# Access Compliance Report

## Public Rights-of-Way

Intersection ID: 50710	Main Street: STEELE_CREEK_RD	Cross Street: ARRIVAL_DR	Location: SW
ADA ID: C79C1101DCC1	Ramp Type: Para	Initial Pass/Fail: Fail	Overall Compliance: No
Codes/Mitigation Info/Possible Solution			Severity Score: 10
			Field Measurements/Component Compliance

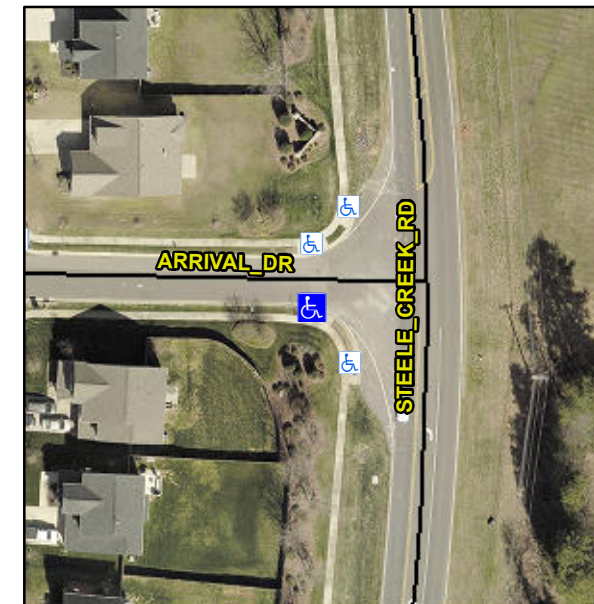
**R304.5.1, R304.5.3**

Compliance	Description	Data	Compliance	Description	Data
N/A	Ramp Length LT (in)	52.0	N/A	Ramp Length RT (in)	93.0
No	Ramp Width LT (in)	46.0	No	Ramp Width RT (in)	41.5
Yes	Ramp Slope LT (%)	5.0	Yes	Ramp Slope RT (%)	5.4
No	Ramp XSlope LT (%)	2.1	No	Ramp XSlope RT (%)	3.5
N/A	Landing Length (in)	N/A	N/A	DWS Provided?	N/A
N/A	Landing Width (in)	N/A	N/A	DWS Contrast?	N/A
N/A	Landing Slope (%)	N/A	N/A	DWS Length (in)	N/A
N/A	Landing X Slope (%)	N/A	N/A	DWS Full Width?	N/A
N/A	Landing Curb? (Y/N)	N/A	N/A	DWS Offset (in)	N/A
N/A	Shared Landing?	N/A			
N/A	Gutter Ponding?	N/A	N/A	Gutter Slope (%)	N/A
N/A	Gutter Lip Ht (in)	N/A	N/A	Gutter X Slope (%)	N/A
N/A	Painted X Walk1?	No	N/A	Painted X Walk2?	N/A
	X Walk 1 Direction	To N		X Walk 2 Direction	N/A
N/A	X Walk 1 Width (in)	N/A	N/A	X Walk 2 Width (in)	N/A
	X Walk 1 Slope (%)	0.9		X Walk 2 Slope (%)	N/A
	X Walk 1 X Slope (%)	0.9		X Walk 2 X Slope (%)	N/A
N/A	Ramp inside XWalk1?	N/A	N/A	Ramp inside XWalk2?	N/A

Road Slope (%)	N/A	N/A	Clear Space?	N/A
	Road X Slope (%)	N/A	N/A	Clear Space to XWalk (in)	N/A
N/A	Any Obstructions?	N/A	N/A	Storm Grate/Utility Hazard?	N/A
	Obstruction Type			Storm Grate/Utility Type	
		N/A			N/A
			Yes	Surface Condition? (G/P)	Good
			N/A	Curb Slope (%)	9.3

**Remove & Replace Entire Ramp.**
